Access Compliance Report

Public Rights-of-Way

(Curb Ramps)

Intersection ID: 13223	Main Street: BIRCHCREST_DR	Cross Street: WOODLEAF_RD	Location: SW
ADA ID: 4B488B9955C3	Ramp Type: Perp	Initial Pass/Fail: Fail	Overall Compliance: No
Severity Score: 25			
Codes/Mitigation Info/Possible Solution		Field Measurements/Component Compliance

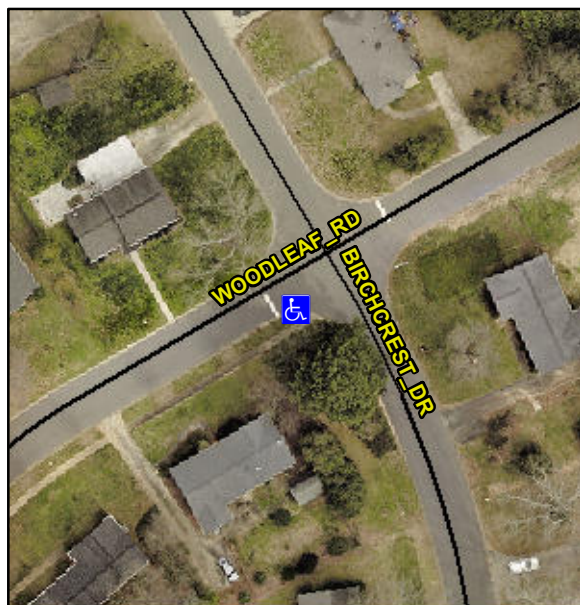
Not Found, R304.2.2

Compliance	Description	Data	Compliance	Description	Data
N/A	Ramp Length (in)	26.5	No	Ramp Slope (%)	13.1
Yes	Ramp Width (in)	48.0	Yes	Ramp XSlope (%)	1.9
N/A	Flare Type LT	N/A	N/A	Flare Type RT	N/A
N/A	Flare Slope LT (%)	N/A	N/A	Flare Slope RT (%)	N/A
N/A	Flare Traversable LT?	N/A	N/A	Flare Traversable RT?	N/A
N/A	Landing Length (in)	N/A	N/A	DWS Provided?	N/A
N/A	Landing Width (in)	N/A	N/A	DWS Contrast?	N/A
N/A	Landing Slope (%)	N/A	N/A	DWS Length (in)	N/A
N/A	Landing X Slope (%)	N/A	N/A	DWS Full Width?	N/A
N/A	Landing Curb? (Y/N)	N/A	N/A	DWS Offset (in)	N/A
N/A	Shared Landing?	N/A			
N/A	Gutter Ponding?	N/A	N/A	Gutter Slope (%)	N/A
N/A	Gutter Lip Ht (in)	N/A	N/A	Gutter X Slope (%)	N/A
N/A	Painted X Walk1?	No	N/A	Painted X Walk2?	N/A
	X Walk 1 Direction	To E		X Walk 2 Direction	N/A
N/A	X Walk 1 Width (in)	N/A	N/A	X Walk 2 Width (in)	N/A
	X Walk 1 Slope (%)	3.8		X Walk 2 Slope (%)	N/A
	X Walk 1 X Slope (%)	0.2		X Walk 2 X Slope (%)	N/A

Remove & Replace Entire Ramp.
